FAQ Title Transient Fire Heat Release Rate Curves

FAQ Number 18-0019 FAQ Revision 0 (Draft v6)

Table 2
Maximum Steady Burn Duration given Conservation of Test Energies

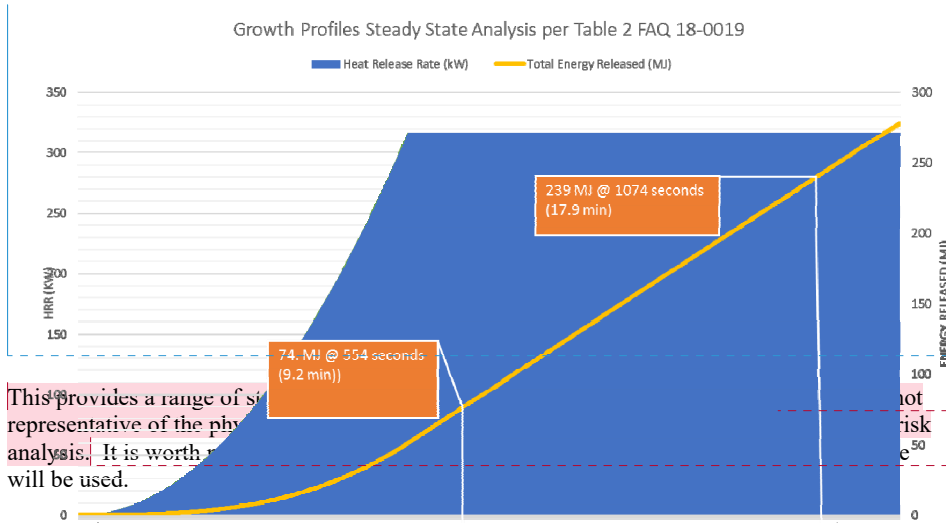
Commented [MB5]: This approach only calculates the total energy released during the growth phase of a fire or given test but appears to ignore any energy released thereafter.

Commented [MN6]: Using this value when corresponding to the actual test results overlooks the distribution of possible heat release values presented in NUREG-6850 and only focuses on the 98th percentile HRR point value. While this can be used for illustrative purposes it is at odds with the severity factors that are used in practice when applying the current method on a scenario basis.

Commented [MN7]: This would be a more illustrative tool if the HRR's were normalized to show how the new generic HRR profiles match up with previous test data

Commented [MB8]: None of the fires in this table were 317 kW.
